Review of Environmental Factors Addendum

NST Wet Well Desilting - Extended Silt Bin Storage

Figure 1 Proposal change

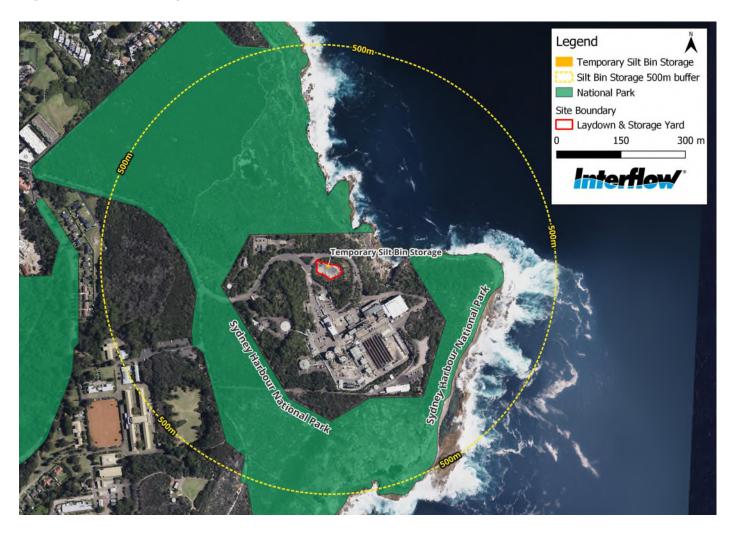
Aspect	Detailed description		
Proposal location	The works are located at the North Head Waste Resource Recovery Facility (WRRF) ST0020, Lot 1 DP604428, in the Northern Beaches local government area.		
Approved REF	Northside Storage Tunnel Wet Well Desilting and Decline Tunnel Rehabilitation August/September 2023		
Proposal scope	The NSOOS rehabilitation program involves desilting and rehabilitation of the rock lined NSOOS tunnel. Wastewater flows within the NSOOS are being diverted to the NST to enable these works. Due to this wastewater diversion the NST Wet Well has filled with silt and debris. This requires removal to ensure continued operation of the NST and to provide continued capacity for the diversion needed by the NSOOS rehabilitation project.		
Proposal change	To facilitate desilting works, it is necessary to store silt bins above ground for more than 24 hours. However, this requirement conflicts with the REF mitigation measure which states potential odours must be minimised by ensuring silt and debris are stored for less than 24 hours in sealed and covered skip bins on a ventilated site above ground. Under the following circumstances, greater than 24 hour limit will be allowed: Desilting activities conducted on Fridays require storage of silt bins over the weekend. Disposal operations can be delayed during public holidays. Breakdowns of essential equipment, such as hook trucks, can create backlogs and silt bins may require longer on-site storage. Landfill closures due to rainfall can delay silt bin disposal. The contactor commits to disposing of dewatered silt as soon as is reasonably practicable.

Justification for proposal change	The proposed change is required to facilitate efficient operation of desilting works in the circumstances described in the proposal change above, if the 24 hour limit cannot be achieved. By allowing the storage of silt bins above ground for longer than 24 hours, delays in desilting operations can be minimised. The potential impacts of additional storage time are limited as the storage area is set away from sensitive receivers within the boundary for the WRRF. In addition, this Addendum proposes additional mitigation measures (section 5) to maintain the intent of the original mitigation while accommodating the practical needs of the desilting operations.
